From: [Marlayna Doell](#)
To: [Gerard P. Van Noordennen-ext](#)
Cc: [tom.magette](#)
Subject: RE: La Crosse RCI Response Follow Up
Date: Thursday, November 3, 2022 4:51:00 PM
Attachments: [image001.png](#)

From: Marlayna Doell
Sent: Wednesday, October 26, 2022 1:04 PM
To: Gerard P. Van Noordennen-ext <gpvannoordennen-ext@energysolutions.com>
Cc: tom.magette <tom.magette@gmail.com>
Subject: La Crosse RCI Response Follow Up

We have had a chance to review the RCI responses from last week for the La Crosse Class 1 FSSR review and wanted to provide some feedback. The responses to the second part of RCI 1 regarding the statistical test for L1-SUB-CDR, RCI 2a, and RCI 2c are sufficient to confirm the staff’s

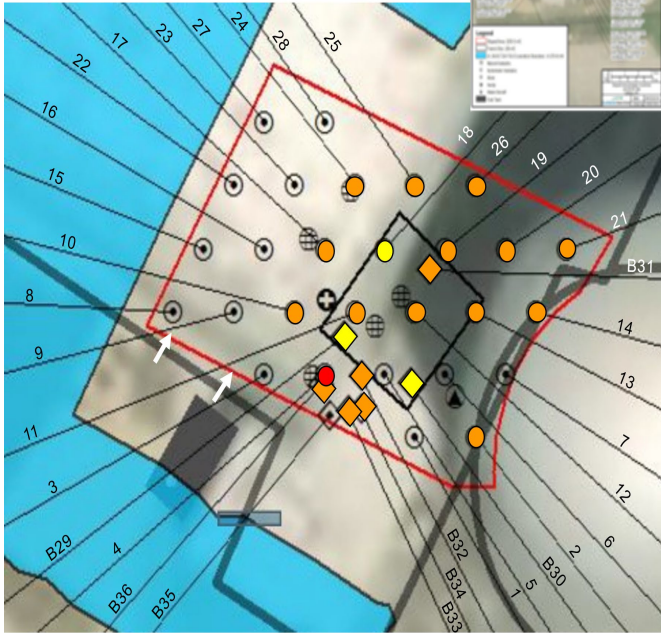
2. LATERAL EXTENT: There is a reasonable degree of certainty that the area of elevated contamination did not extend outside of the red boundary in the figure below, nor that the nearby excavation and survey activities would have the potential to spread contamination outside the originally identified area (i.e., into other survey units).

Given that the RPGPA was backfilled before GeoProbe sampling, the staff needs to understand why the higher levels of contamination appear to be in the backfill portion of the elevation. The figure below shows the systematic and judgmental sample locations that exceeded MDC, and which stratum contained the maximum concentration.

- Cs-137 24.4 pCi/g (B4) adjacent to 1.2 pCi/g (B36); immediately to east are 11.1 pCi/g (B33), and 6.05 pCi/g (B32);
- RPGPA trench box 618 ft elev
- GW flow generally westward to WSW
- Water table fluctuates 620 to 630 ft AMSL
- Ground surface at the time of GeoProbe is apparently 627 ft AMSL
- Top stratum sampled at 624-627 ft

- Above operational DCGL, top stratum (624-627 ft elevation)
- ◆ Above MDC, top stratum (624-627 ft elevation)
- ◆ Above MDC, 2nd stratum from top (621-625 ft elevation)
- ↑ Angled GeoProbe, 20 ft "depth" from edge of building from ~639 ft AMSL was part of initial characterization

- Given that the GeoProbe sampling results containing the 24.4 pCi/g (and the nearby 11.1 pCi/g and 6.05 pCi/g) were in the uppermost stratum of the RPGPA, and assuming that at these locations that stratum was comprised of backfill, why was this level of contamination present in the backfill material? Given the steepness of the sloped walls of the RPGPA on three sides, only the GeoProbe locations immediately adjacent to the survey unit boundary would be expected to contain soil from below excavation surface in the topmost stratum (624'-627' elevation).

- The RCI response states, “The RPGPA (TDS-B) was the second unit surveyed and was backfilled prior to the survey.” The team acknowledges that groundwater was intruding into the trench box area of the RPGPA (black boxed area in the figure), but is questioning if there were any scans of the soil that was not covered in water prior to backfill being emplaced over the entire survey unit – that is, the area that is inside the red box but not in the black trench box square in the figure.
